Work Order ID 132258

Item Name: Fwd Crosstube - High 407

DRAWING NO. D407-667-145	TITLE CROSSTUBE ASS'Y (407 HIGH FWD)	REV. C	DART AEROSPACE LTD ENGINEERING ORDER		D.E.O. NO. D407-667-145-C-1	SHEET NO. SHEET 1 OF 1	SCALE NTS
DRAWN 9	CHECKED ASS	MFG. APPR. 183	APPROVED WD		DE APPR. H		
DATE 11.07.15	DATE 11.07.22	DATE 11.07.22	DATE 11/07/22		DATE 11.07.21

DRAWING NO. D407-667-145	TITLE CROSSTUBE ASS'Y (407 HIGH FWD)	REV. C	DART AEROSPACE LTD ENGINEERING ORDER		D.E.O. NO. D407-667-145-C-2	SHEET NO. SHEET 1 OF 1	SCALE NTS
DRAWN AJS	CHECKED	MFG. APPR.	APPROVED	DE APPR.	DATE 12.08.02	DATE 12.08.02	DATE 12.08.02

DETAIL P
BONDING STRAP INSTALLATION 2 PL

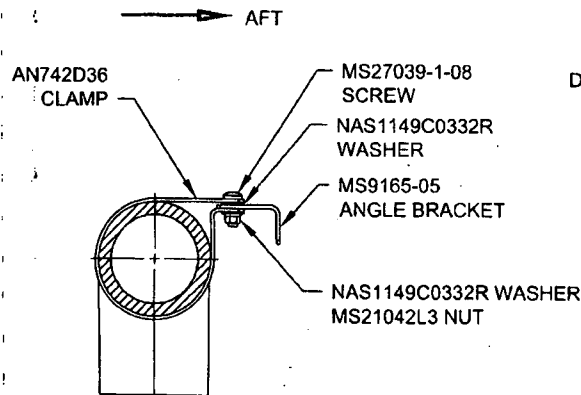
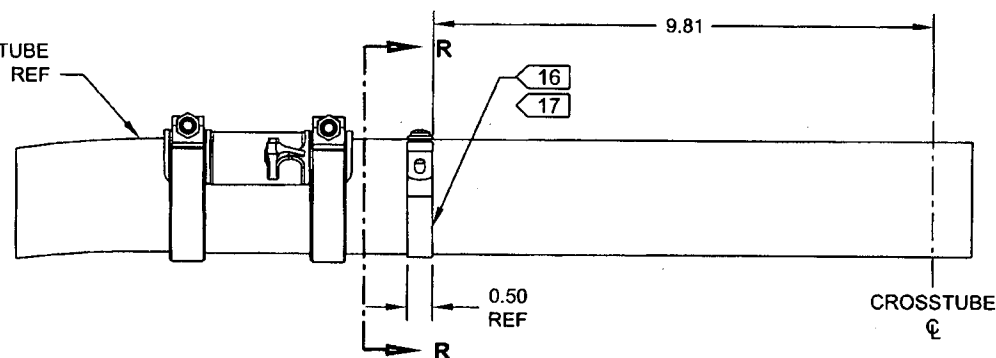
ADD ELECTRICAL GROUNDING STRAP

- 16) MASK AREA UNDER CLAMP PRIOR TO PAINTING
- 17) SEAL EDGES WHERE AN742D36 CLAMP MEETS WITH THE CROSSTUBE USING SIKAFLEX-241/-291 OR MIL-S-8802 CLASS B2 OR PROSEAL 890 SEALANT
- 18) PERFORM RESISTANCE CHECK TO ENSURE MAX RESISTANCE IS 10 MILLIOHMS
